Project Name: Arbor Village

Subdivision Arbor Village 1st Add
 Date 4/6/77 Item # 27-77
 Petitioner Blain Ford

PRELIMINARY PLAN FOR
FIRST ADDITION TO ARBOR VILLAGE

Re: FILE #27-77 - FINAL PLAT FOR FIRST ADDITION TO ARBOR VILLAGE.

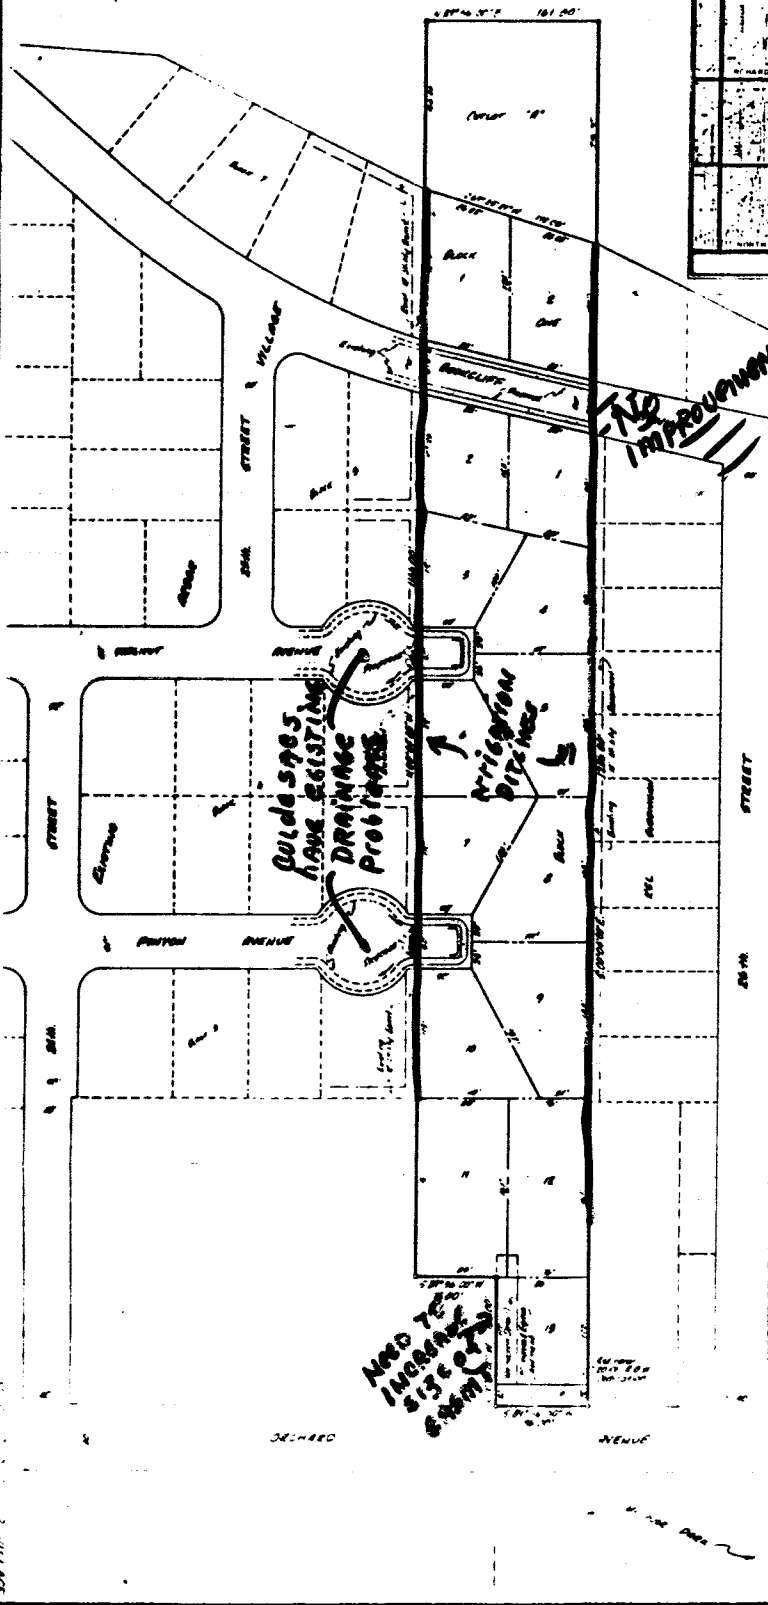
We have reviewed the plat of the "1st Addition of Arbor Village Subdivision" and have found the utility easements as shown on the plat to be inadequate. Mountain Bell will require a Fifteen (15) foot utility easement along the North lot line of Lots 1 and 2 in Block One; and a Fifteen (15) foot utility easement along the East lot line of Lot 2 in Block One; and a Ten (10) foot utility easement along the North lot line of Lots 3, 4, 7, 8, 11 and 12 of Block Two; and a Ten (10) foot utility easement along the South lot line of Lots 1, 2, 5, 6, 9 and 10 of Block Two as shown on the attached plat.
